RIGGING ADVISORY CIRCULAR

RAC No. 427 Rev. A

SUBJECT: PARACHUTES DE FRANCE PRODUCT SERVICE BULLETINS

APF POLICY: Parachutes de France Service Bulletins 910101, 920701, 920702, 92003, 92004, 92005 and 92006 shall be actioned in accordance with the instructions contained therein.

ADDITIONAL CLAUSE TO BS Nr 92003
MODIFICATION OF CUTAWAY SYSTEM ON GALAXY EQUIPMENT

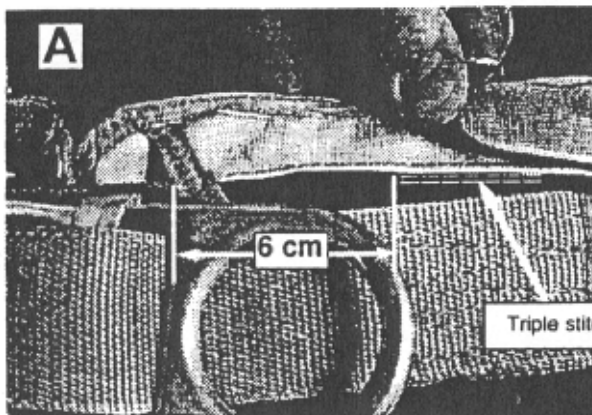
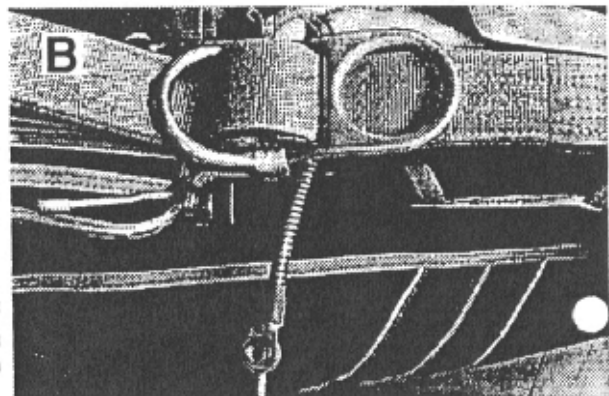
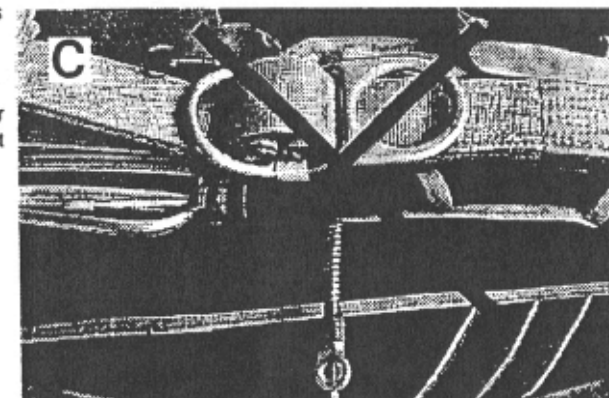
- 1** Unpick the stitches for 6 cm (see picture A) and secure the remaining 3 cm long seam with 2 back stitches (see pict. A).

- 2** Change the routing of the left release housing: it must go over the reserve ripcord housing (see picture B for right routing).

Note: picture C shows the former routing

- 3** Remove the right release housing from the clamps: first cut the ribbon wrapped around one housing, then break the clamps with a pincers.

- 4** Put in the new release housing and secure both release housings with two tackings on the Type 12 webbing.

HOW TO RECOGNIZE THE DIFFERENT VERSIONS OF MINI-RISERS

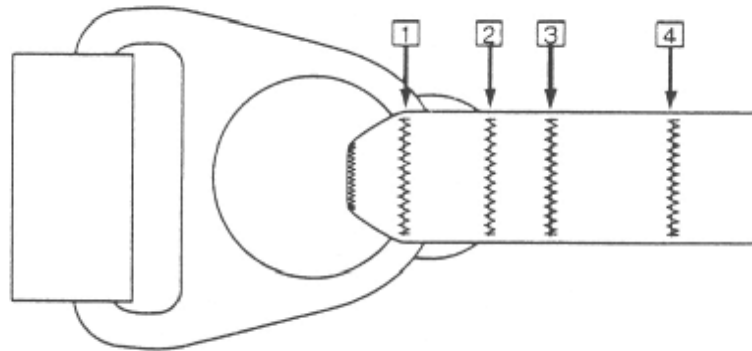
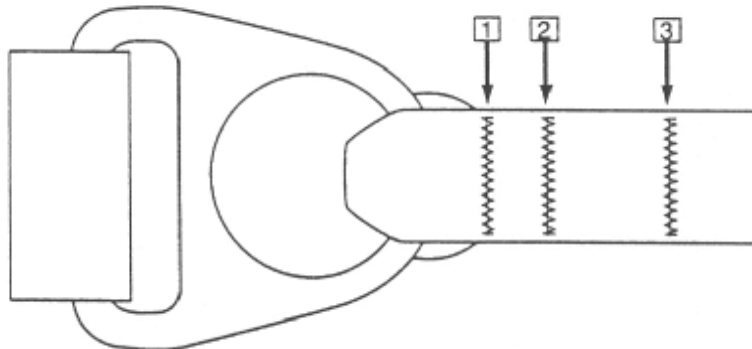
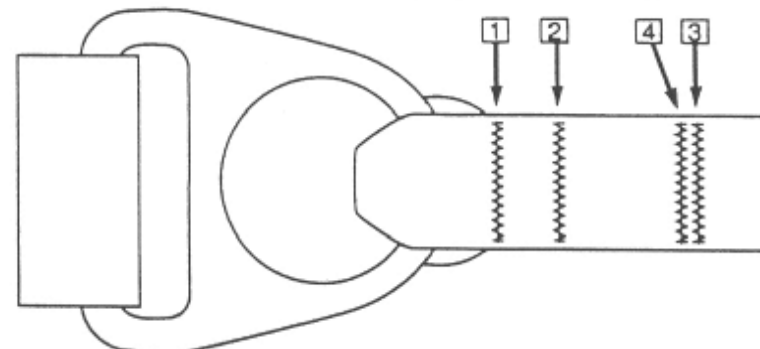
1) All versions manufactured before 20-10-92 (without identification stamp) carry 4 well-spaced bartacks, of which the lowest one is at the level of the harness ring. In addition, there is a bartack folding the webbing at the end of the riser, where the middle ring is attached.

ATTENTION: These risers may not function properly! It is mandatory to verify airworthiness with the help of a suspended harness. In case of high release force, or no release, return the risers to our factory for a modification free of charge.

2) Mini-risers built between 20-10-92 and 25-04-93 are marked with a stamp "0" (zero) between the two legs. They carry only three bartacks, of which the first one is positioned a lot higher than before.

3) Effective 24-04-93 we have added a fourth bartack just below the top one, to reinforce the attachment of the small lip. Note that this bartack is placed on the inside, so as not to affect the mechanical dimensions. This latest generation of mini-risers are marked with stamp "1" (one) between the two legs.

Bulletin service Safety bulletin N° 92005

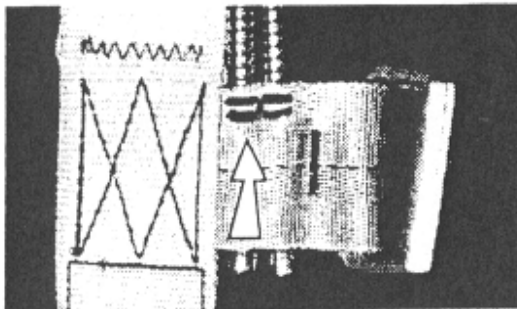
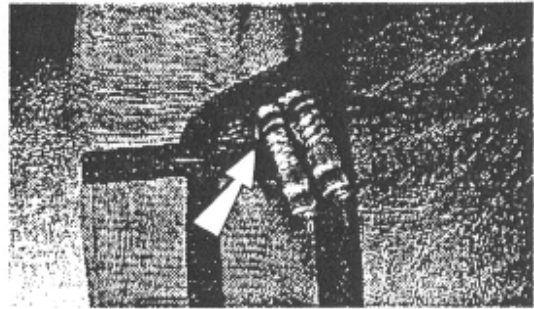
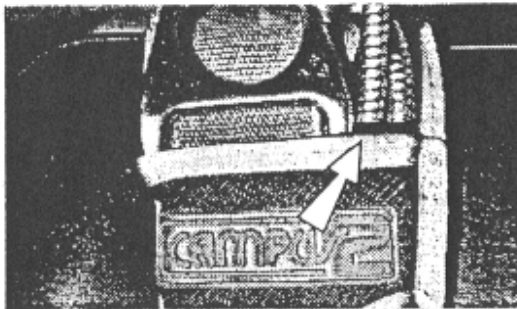
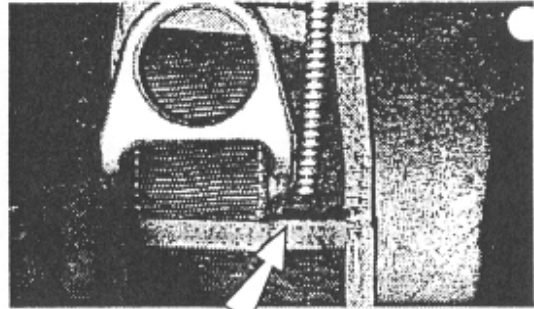
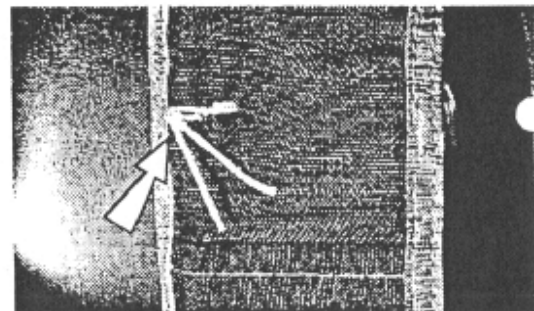
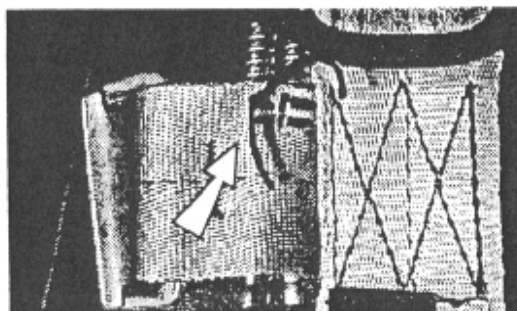
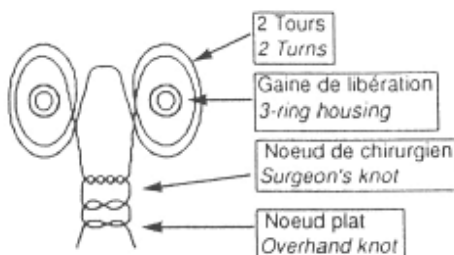
Position of handtackings to secure 3-ring housing.

Envers de la fixation
Rear view of tackings

Handtacking instructions: Routing of tacking cord.

Tacking cord: Waxed polyester braided cord, tensile strength 30 kg, P/N PF 90024150.

If one housing can move freely relative to the other, ground the equipment until the following operation has been performed: fixation of both housings by a tacking, as shown on the drawings overleaf.
